Third Party Planning Objection Report in respect of South Dublin County Council planning application, reg. ref. SD22A/0080. The proposed development comprises of 'Detached three storey, four bedroom house in a contemporary design with flat roofs and bedroom balconies; the drainage arrangements are to simply tap into the existing and as approved under planning ref SD11A/0065 and as amended by S15A & SD17A/0163; a new pedestrian and vehicular access boundary walls and new vehicle crossover on lands at Castlefield Avenue Knocklyon adjoining number 5 Knocklyon Road and Mimosa, Castlefield Avenue Dublin 16 and all associated site works' at Lands at Castlefield Avenue, Knocklyon, Dublin 16.

Planning Objection Report

Third Party Planning Objection Report in respect of South Dublin County Council planning application, reg. ref. SD22A/0080. The proposed development comprises of 'Detached three storey, four bedroom house in a contemporary design with flat roofs and bedroom balconies; the drainage arrangements are to simply tap into the existing and as approved under planning ref SD11A/0065 and as amended by S15A & SD17A/0163; a new pedestrian and vehicular access boundary walls and new veh

Fig. 17: The third storey terrace is not mentioned in the public notices

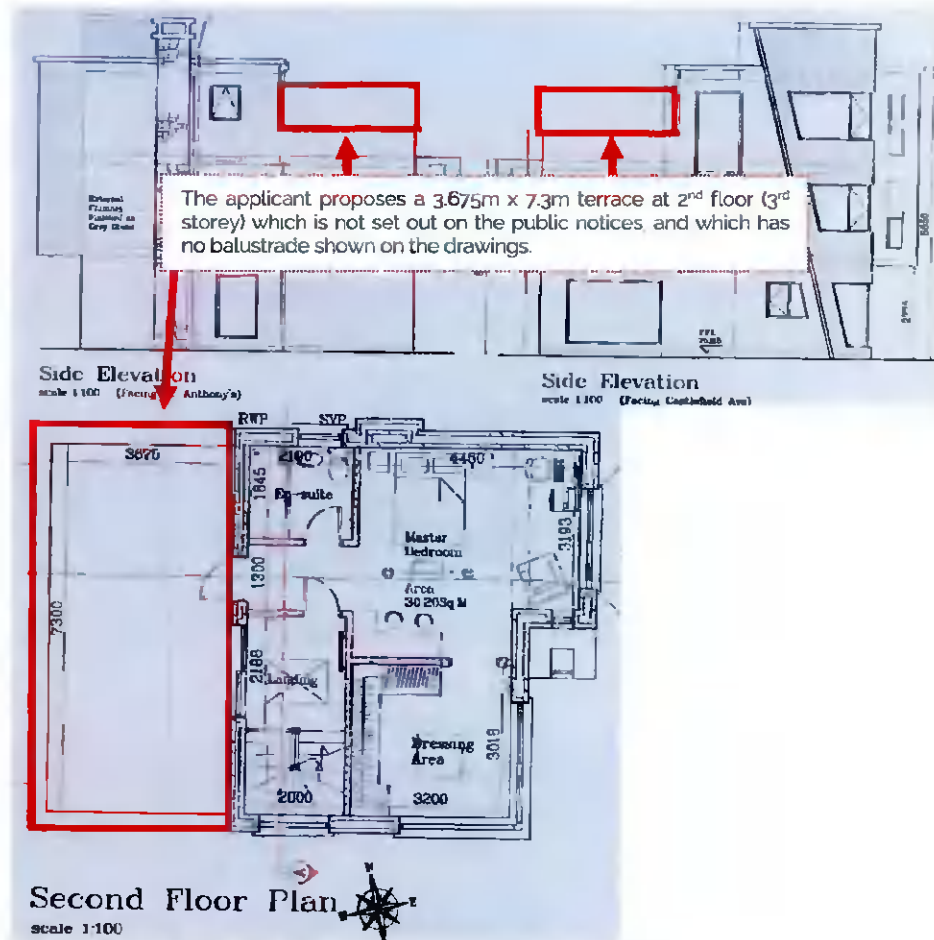
Our client objects to how the applicant proposes a 26.8sq.m terrace at 3rd storey level but this is not mentioned in the public notices. This is a significant part of the applicant proposals with sliding doors and a door out onto its extent. It has the potential to cause significant overlooking. The applicant should be required to re-advertise.

The applicant also provides no balustrades around this massive terrace area which is sited at high level. Balustrades would be required and would add to the visual overbearing appearance of the building especially its side elevations.

Fig. 19: Applicant's Proposed Site Layout Plan sites the front garden adjoining client's rear garden, etc.

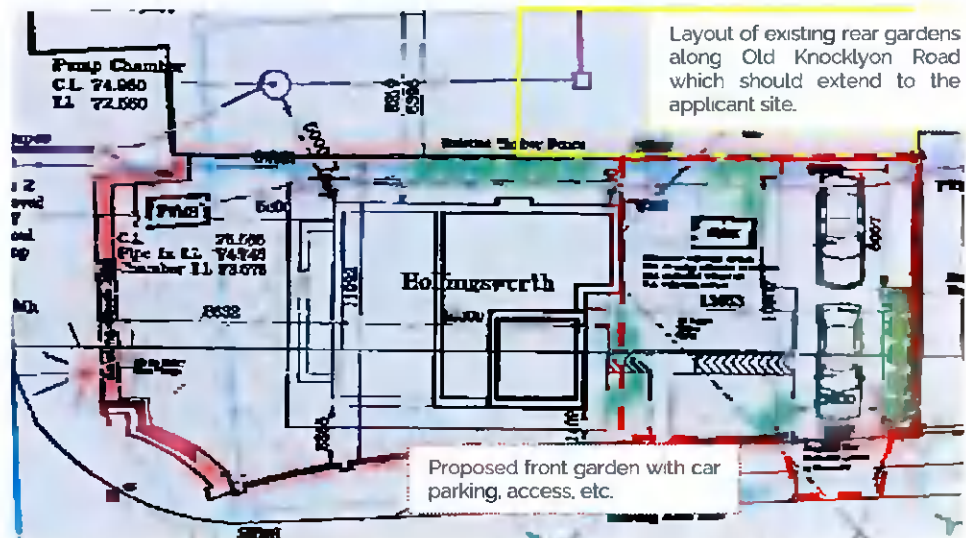
It is not our client's concern or problem that the applicant appears to be proposing this site orientation as they would otherwise have difficulties providing a vehicular entrance and parking within the site. The applicant's siting proposals suggest that this site may not be developable. The applicant's proposal needs to be re-designed such that its rear garden adjoins our client's rear garden.

Fig. 20: Applicant's Proposed Site Layout Plan sites the front elevation adjoining client's rear garden

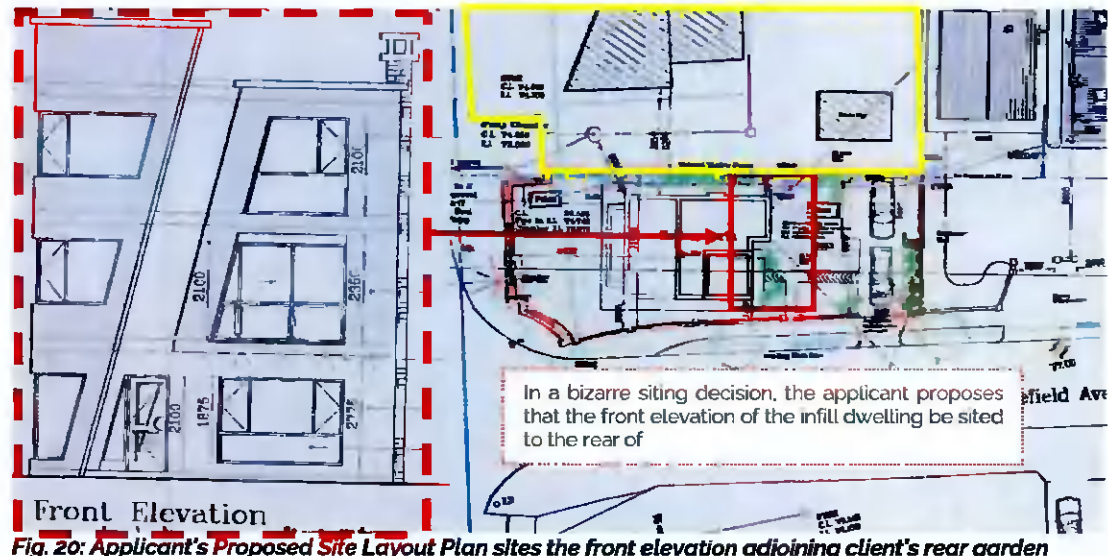
The applicant's infill dwelling is sited and should face Old Knocklyon Road. The dwelling is sited such that it follows the building line along Old Knocklyon Road, but the applicant drawings show the building's front elevation facing east. This is a somewhat bizarre siting and design decision and one our client cannot support.

The applicant's proposed infill dwelling needs to be re-designed such that its front elevation faces west, and its rear elevation faces east. The proposed dwelling should reduce in height to the rear and not increase in height.

Fig. 22: The height of the proposed dwelling's "front" elevation and side elevation facing client's property

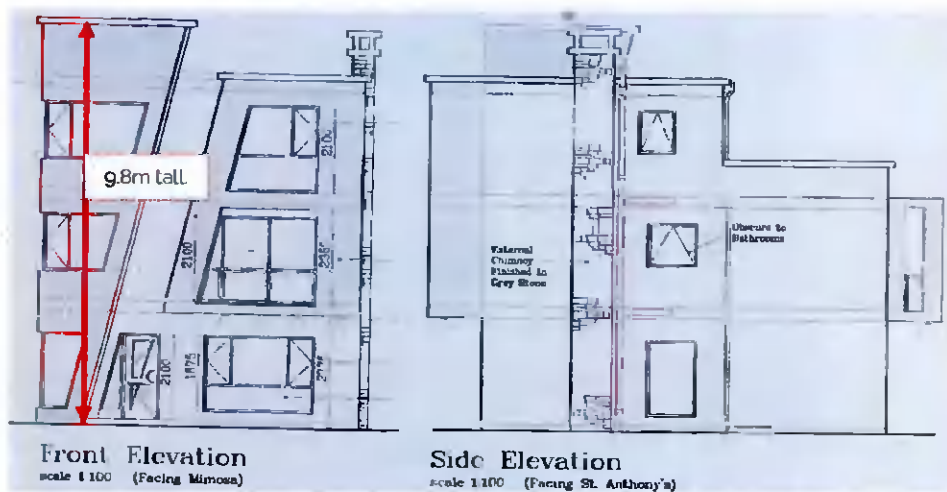
These elevations are too tall and should be pitched roof in accordance with adjoining and nearby dwelling – pitched roofs help to reduce visual impact by grading heights down towards boundaries

Fig. 23: The odd, over-scaled, bulky, and heavily massed appearance of the side elevations

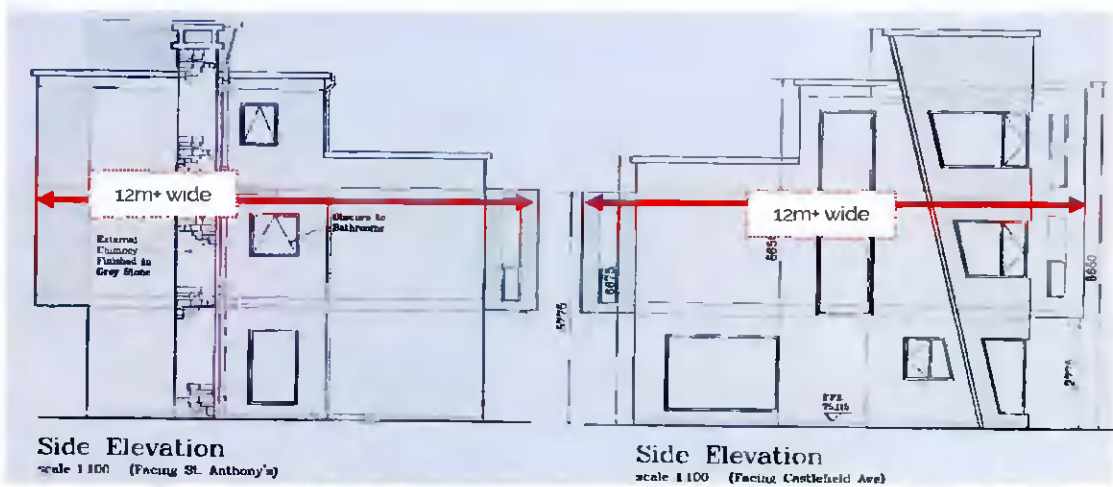
The proposed side elevation facing our client's property would cause the negative residential and visual amenity impacts set out in Section 7.4 of this Planning Observation Report, while the south facing elevation would by its odd, over-scaled, bulky, and heavily massed appearance, detract from the adjoining streetscape where it is sited close to the road.

The building needs to be re-scaled to that of a standard two storey pitched roof dwelling which can fit into this site at an acceptable and contextually compatible scale.

Fig. 31: Shadow thrown by the building at 11am across our client's property

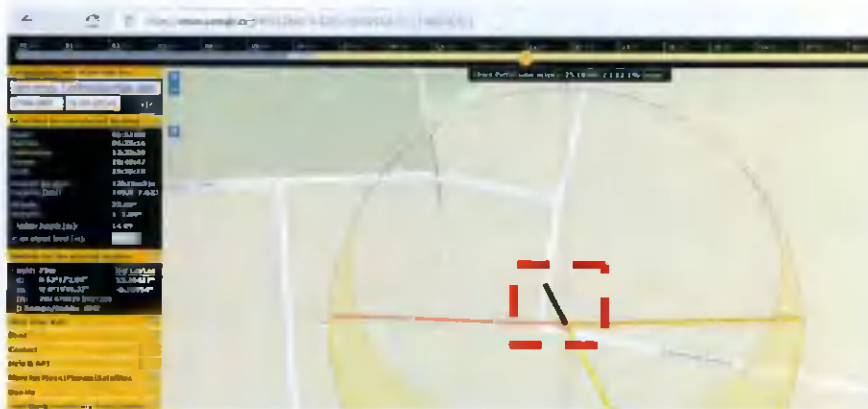
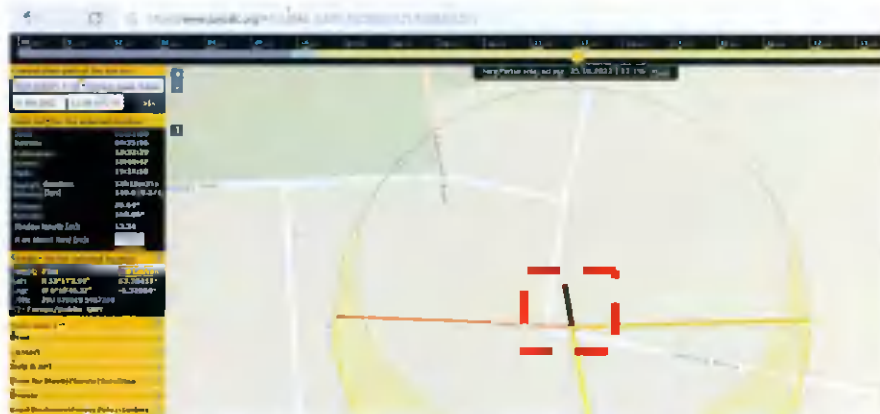
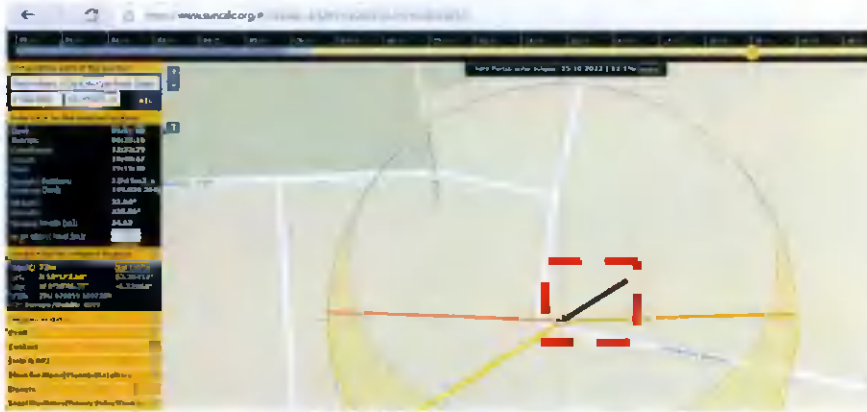
June 21st: The applicant's dwelling would overshadow the southern areas of our client's property from 11am each morning until 4pm in the evening. The shadow lengths arising extend to 8.53m at 9am, to 5.84m at 2pm, and to 8.75m at 4pm. The shadow lengths shorten slightly if one removes the proposed 4th storey element, but not by much. The proposed dwelling causes moderate overshadowing of our client's property on this date. This could be mitigated by reducing the building to a 2 storey flat roofed proposal.

Fig. 44: Shadow thrown by the building at 9am across our client's property

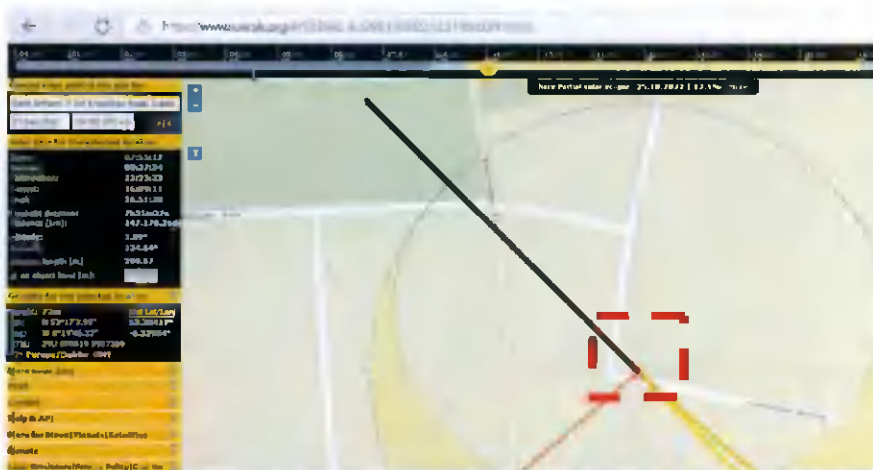
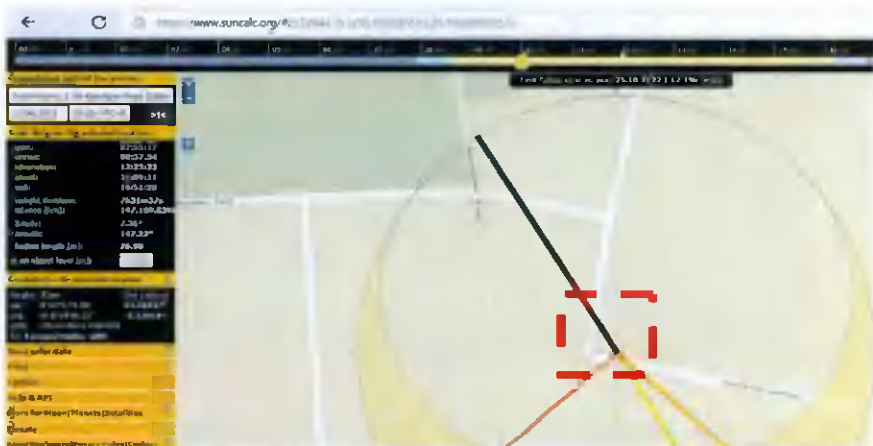
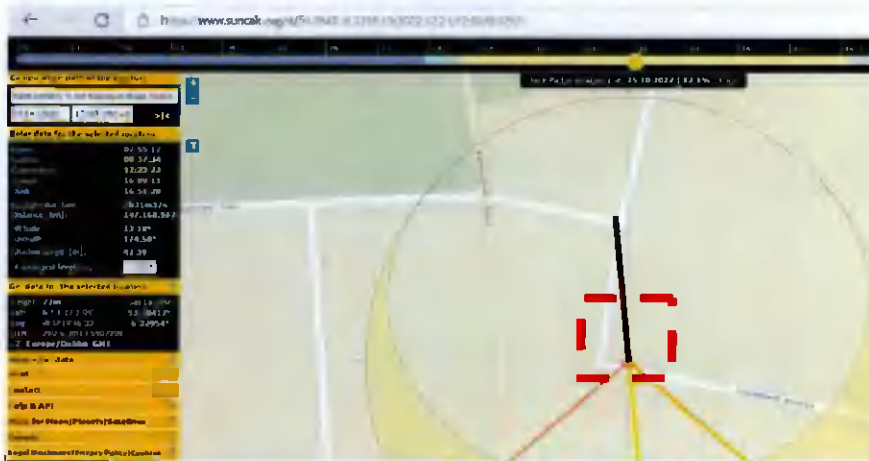
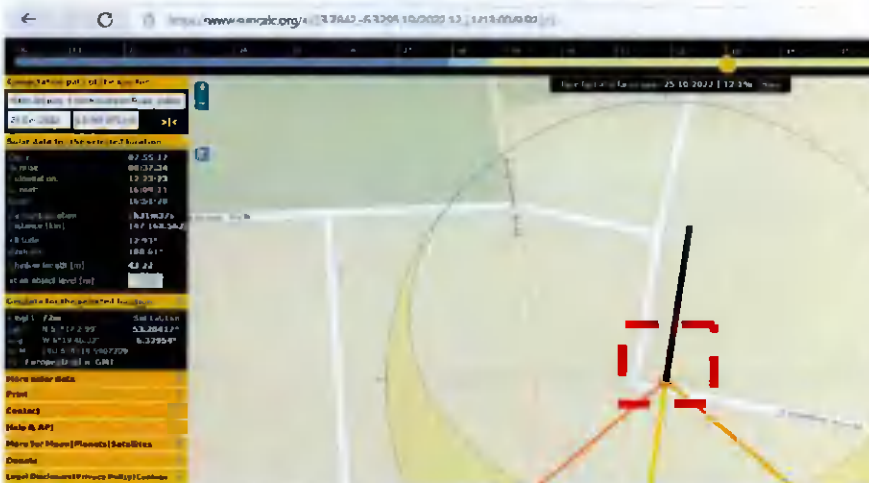
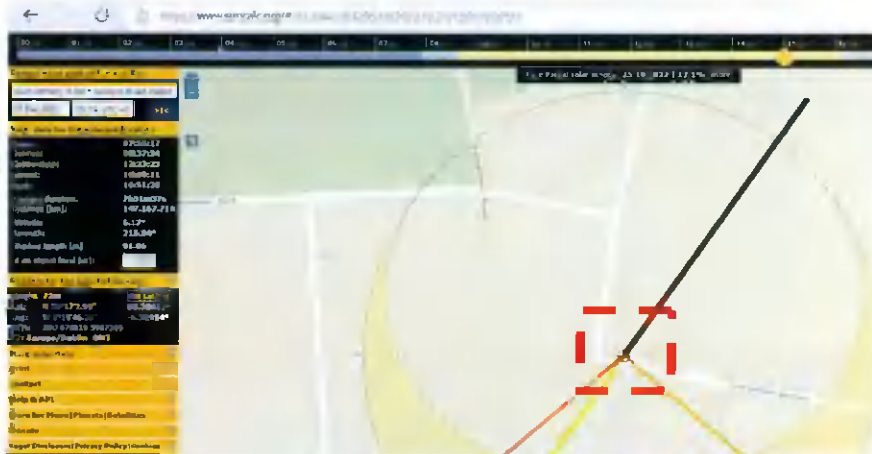
21st December: The applicant's dwelling would overshadow substantial areas of our client's property from 9am each morning until 4pm in the evening. The shadow lengths arising extend to 300.57m at 9am, to 43.22m at 1pm, and to 942m at 4pm. The shadow lengths shorten slightly if one removes the proposed 4th storey element, but not by much. Despite how the sun is low in the sky this time of year and the days are short, the proposed dwelling still causes significant overshadowing of our client's property on this date. This could be mitigated by reducing the building to a 2 storey flat roofed proposal.

Fig. 52: Areas of overlooking concern (1)

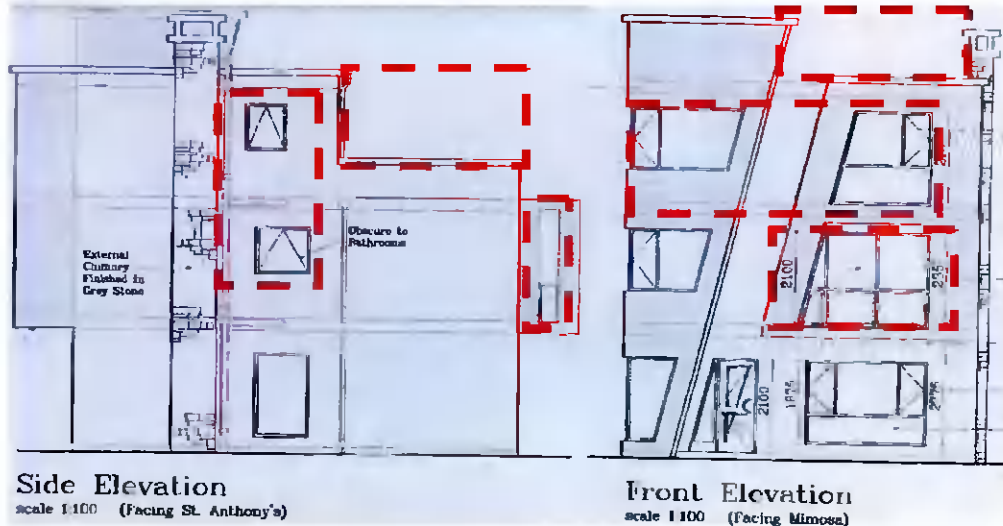
The proposed dwelling has been designed with windows, balconies, a terrace, and a roof which would cause direct overlooking, indirect overlooking, and perception of overlooking impacts from high levels on our client's property. This is not acceptable. The proposal cannot reasonably be granted in the manner submitted

Fig. 54: The proposed rear ("front") elevation to face the permitted dwellings to the east

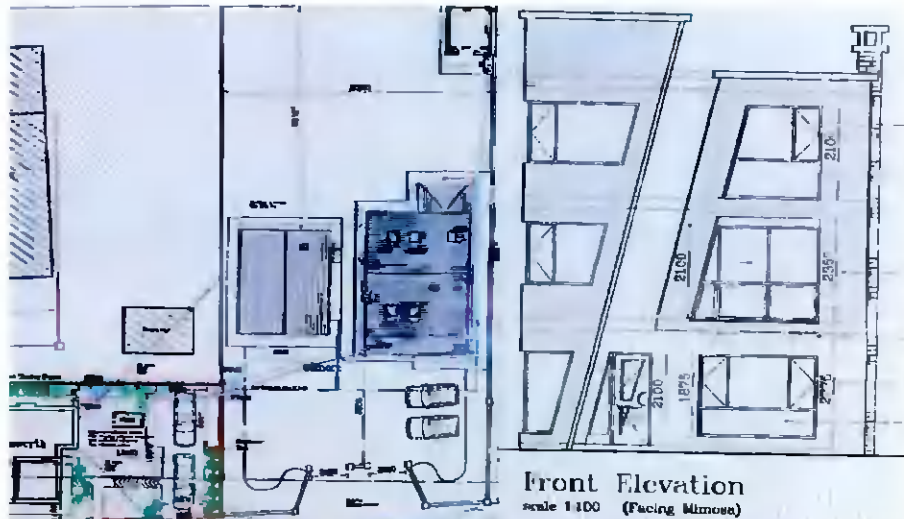
- 1 The proposed infill dwelling would visually overbear onto and be visually dominant in respect of the new permitted dwelling to be sited to the east. The proposed dwelling’s rear (“front”) elevation is too large given the site context.
- 2 The proposed infill dwelling would overlook the permitted dwellings to the east from a first floor balcony and from excessively scaled and tall second floor windows.
- 3 The proposed infill dwelling would overshadow the permitted dwellings to the east in the afternoons and evenings when the sun is in the southwest and west.

The proposed infill dwelling would significantly, negatively, and permanently impact on the residential and visual amenities of the permitted dwellings to the east. It should be refused planning permission.
